August 8, 2011

RE: AHRI Comments on 2013 Building Efficiency Standards Staff Workshop on
Residential Zoned A/C – July 15, 2011 (Docket Number 10-BSTD-01)

Peak Electricity Usage

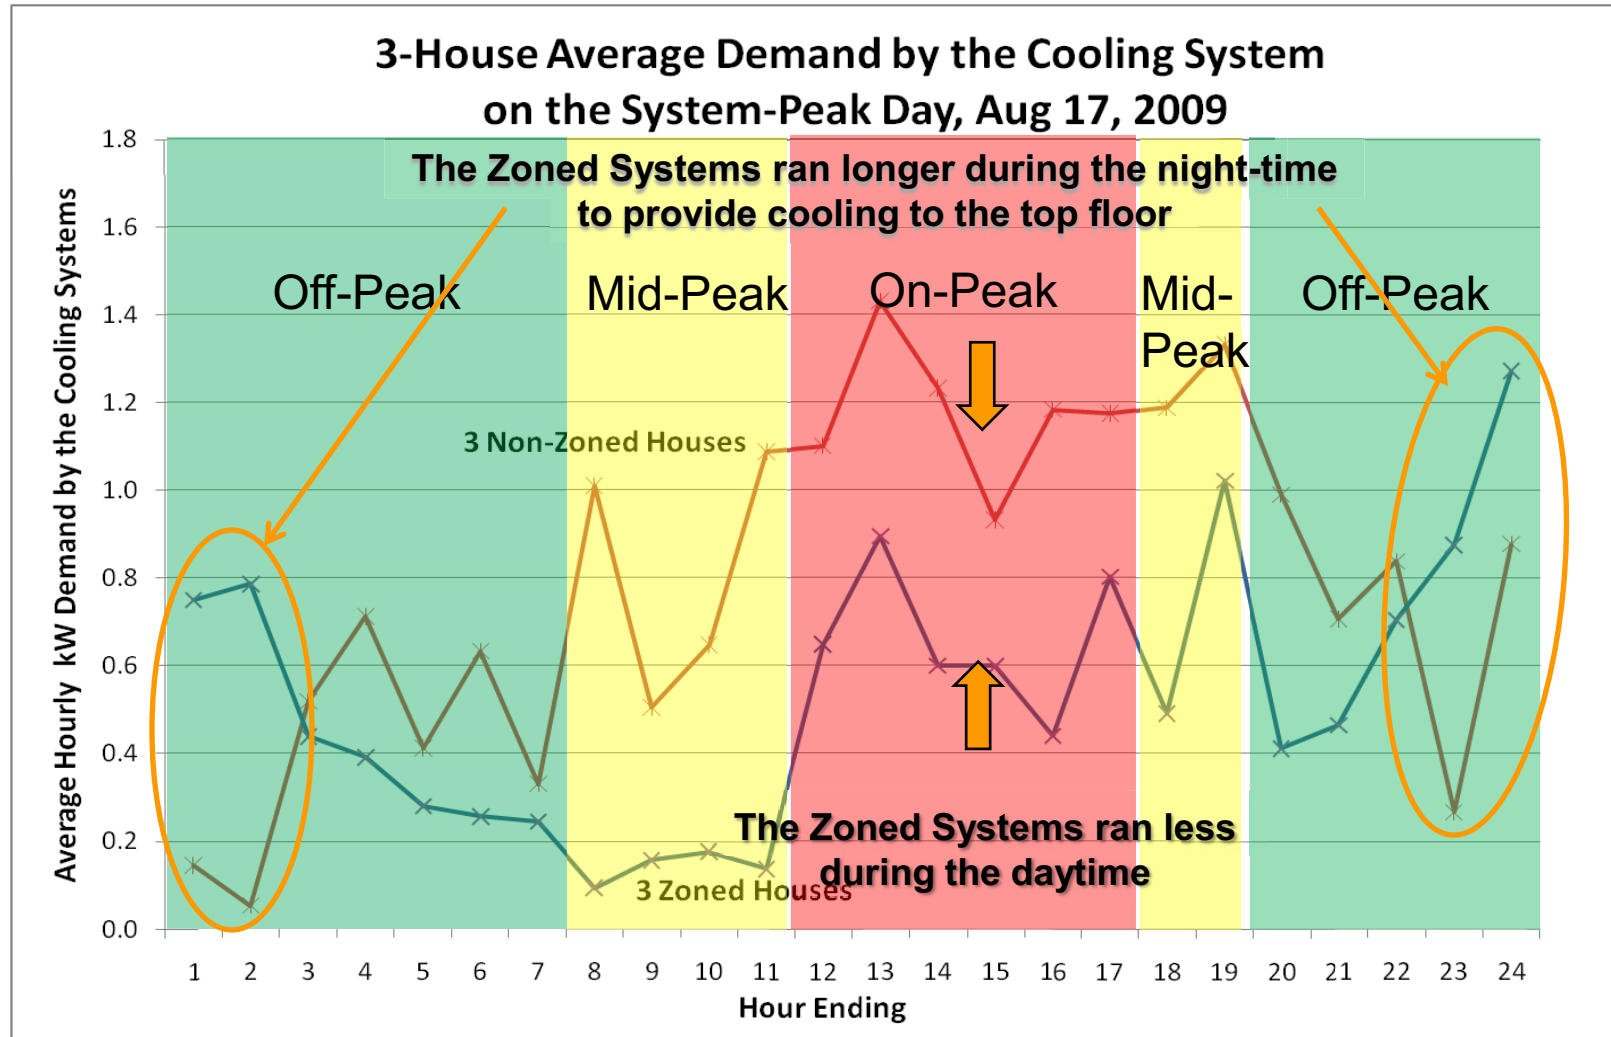
Avg. Conv. 19.3 kWh

Avg. Zoned 12.9 kWh

Zonal Systems (red) Have Low EER

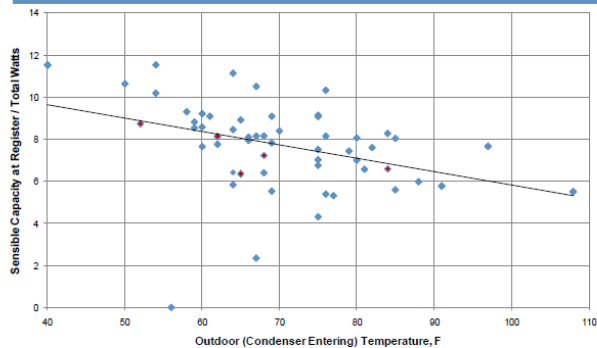
The presenter's presentation from April 12, 2011, shows the total number of homes surveyed with lower than acceptable EER ratings. While only two zoning systems were substantially below the acceptable line, 16 non-zoned systems fell at or below the lowest rated zoned systems. Our point is that there are many reasons for systems not to be performing in the field at their rated efficiency levels. Zoning should not be singled out because of poor installations. The efficiency of each of the underperforming zoning systems can be improved by correcting improper installation techniques. We maintain that the presenters are unfairly critical of zoning. Considering that this study also has a substantial percentage of non-zoned systems, 20% whose efficiencies fall below the acceptable line. Slide 6 from the April 12, 2011 presentation states that 60% of the 80 homes surveyed also had lower than standard cooling air flow.
